## **ADDENDUM NO. 1**

**Bronze Door Vestibule  
Missouri State Capitol Building  
Capitol Complex  
Jefferson City, Missouri  
PROJECT NO.: 02203-02**

BRONZE DOOR  
VESTIBULE

SHEET TITLE:  
INTERIOR ELEVATION &  
SECTIONS

① INTERIOR ELEVATION OF VESTIBULE  
SCALE 3/4"=1'-0"

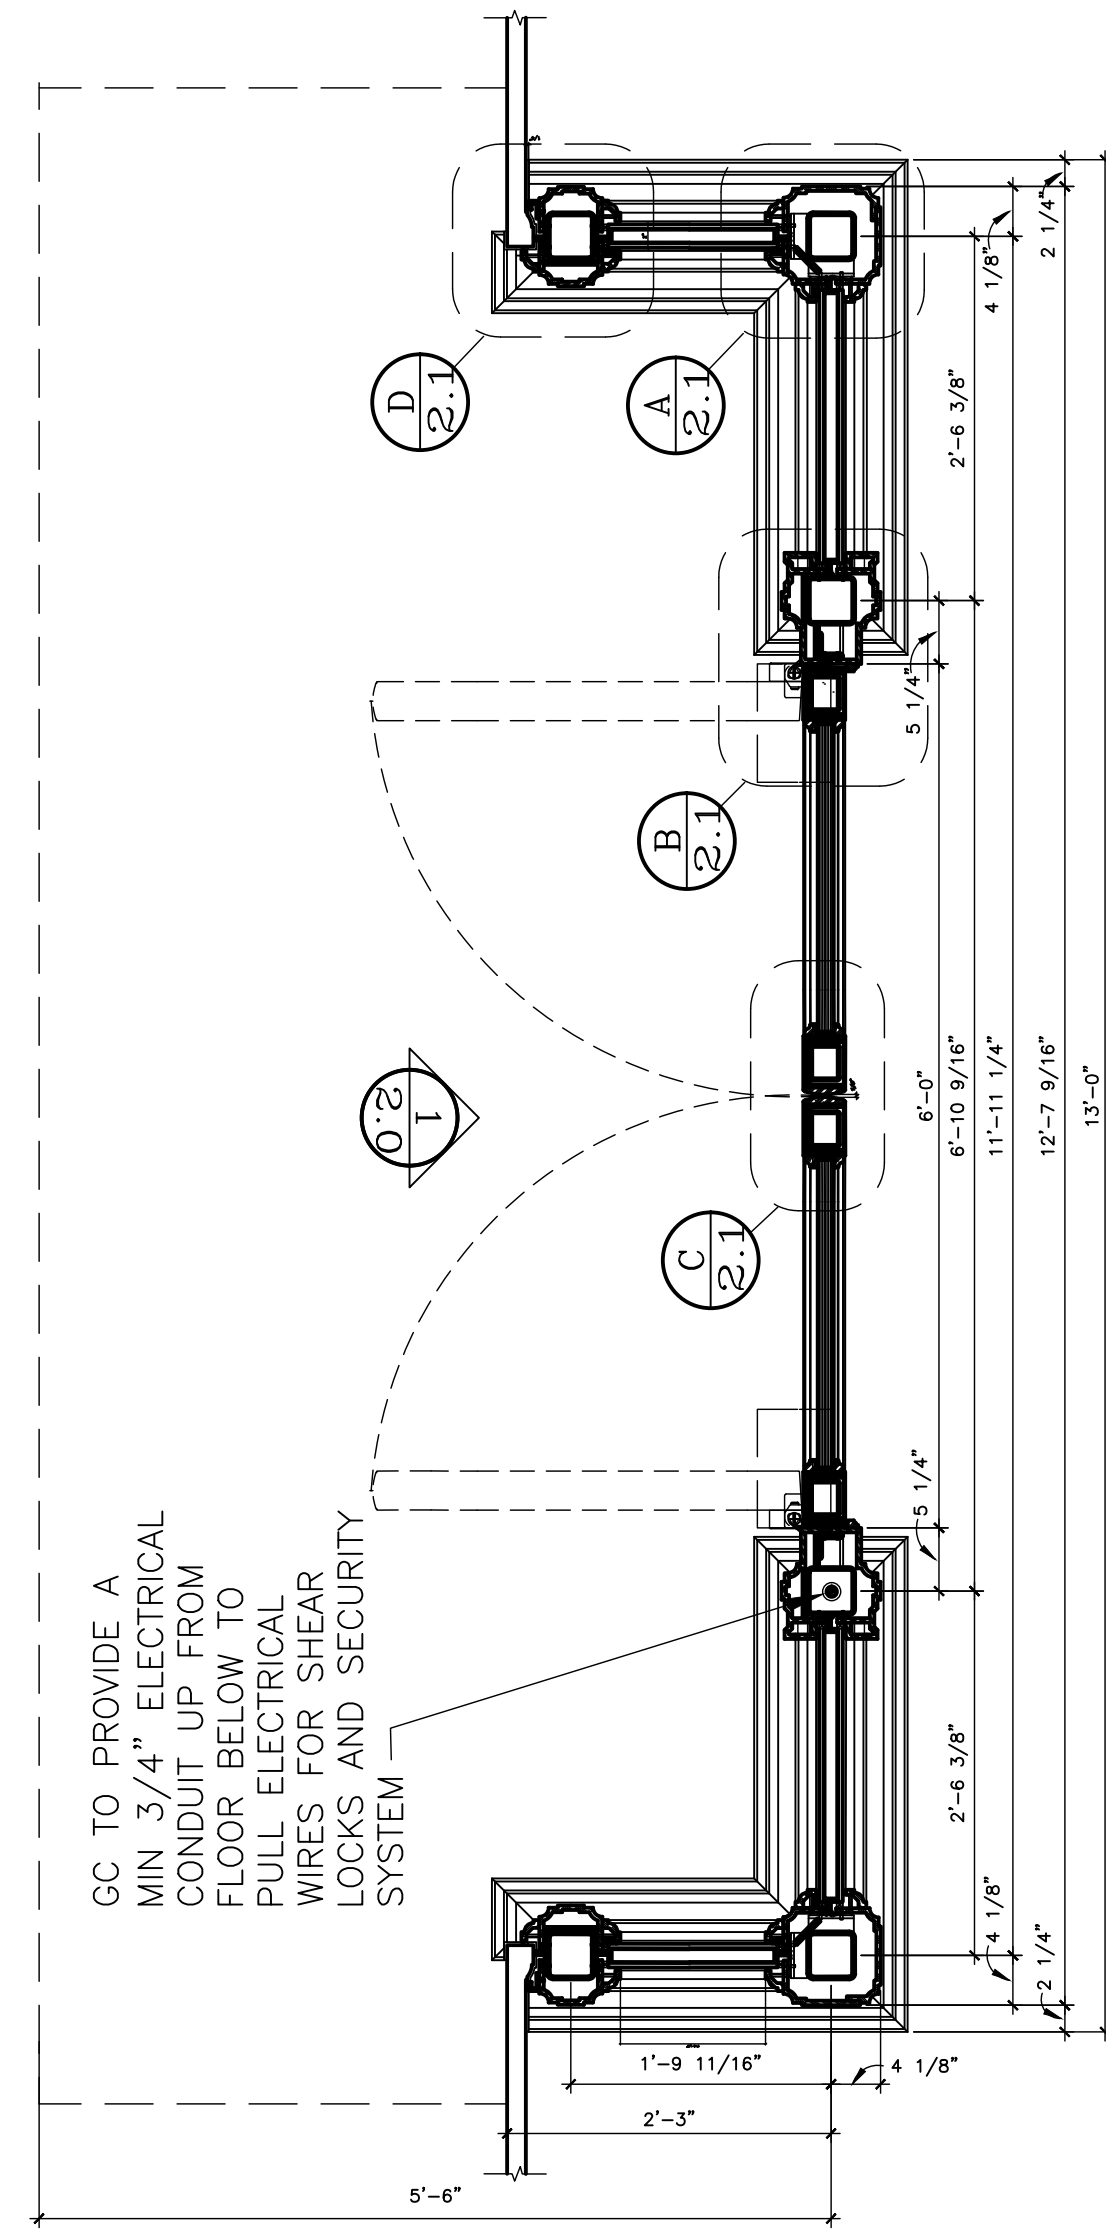
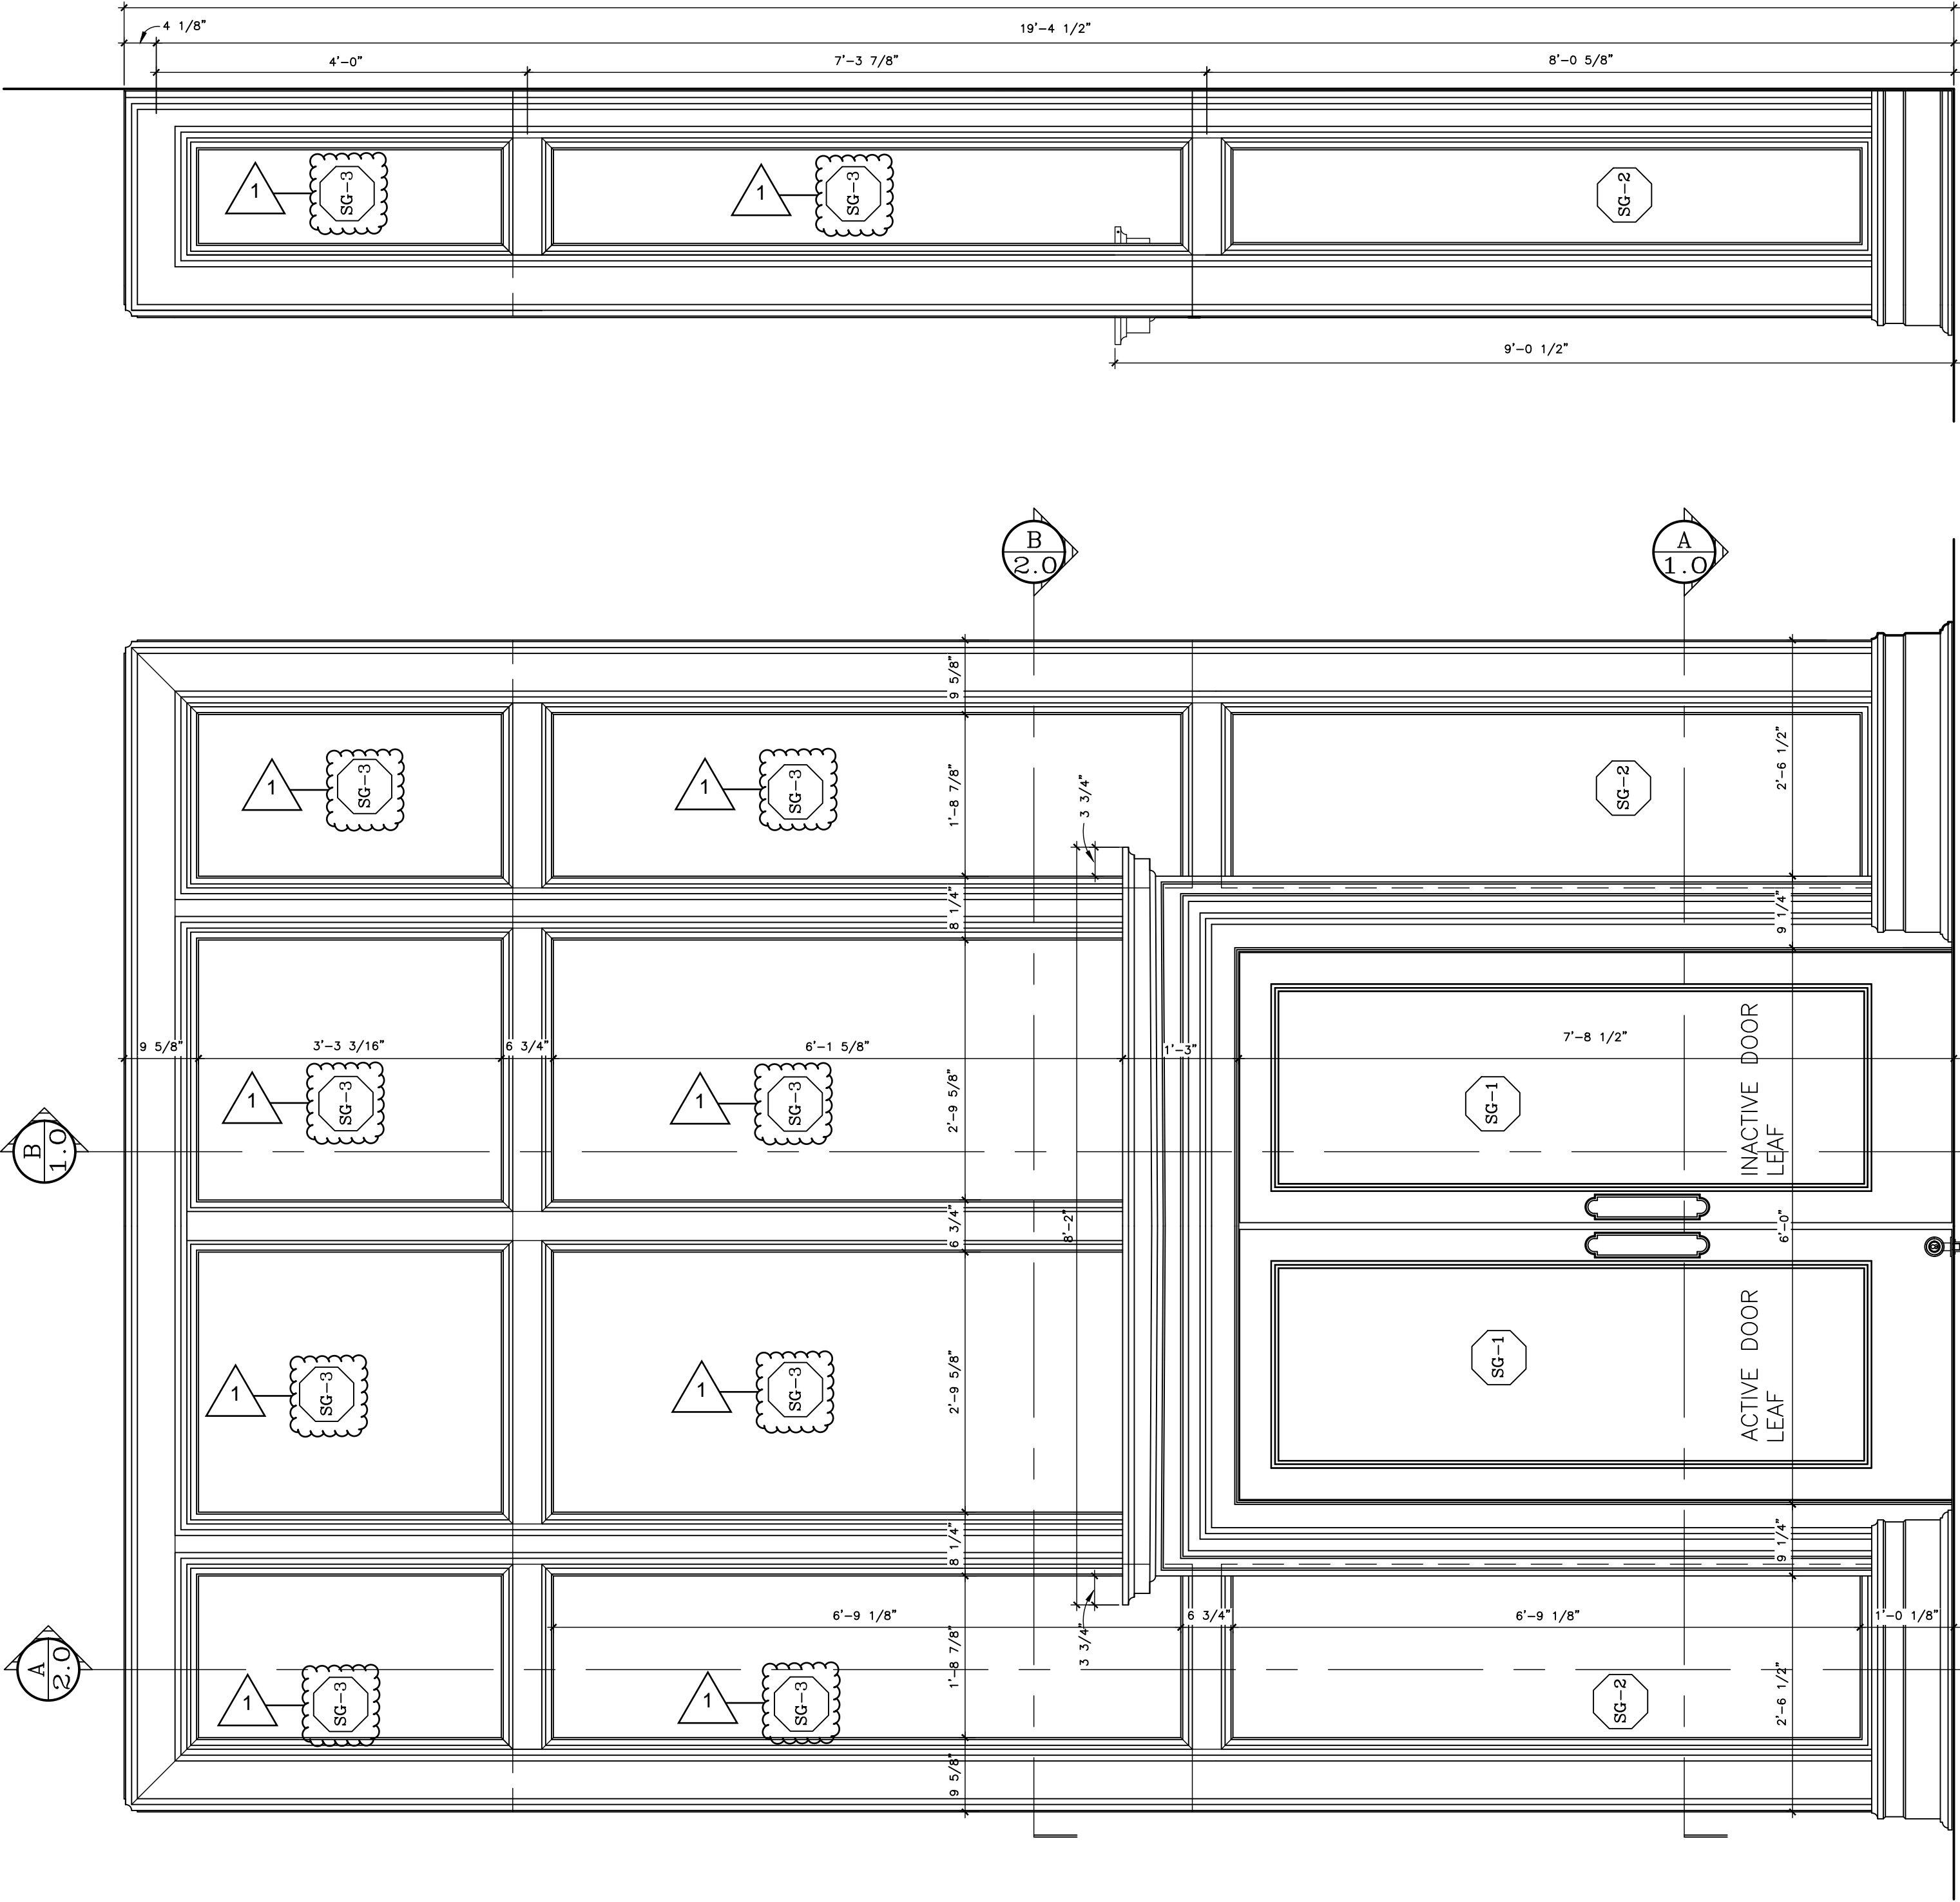
1. Sheet A1.0 – Interior Elevation & Sections:
  - a. Revise detail 1 – Interior Elevation of Vestibule: correct glazing type at upper glazing units to glazing type SG-3.
  - b. Revise detail 2 – Interior Elevation of Vestibule: Add glazing type tags to upper glazing units, noting type SG-3 to be provided.
  - c. Revise detail B – Interior Elevation of Vestibule: Add glazing type tags to upper glazing units, noting type SG-3 to be provided.
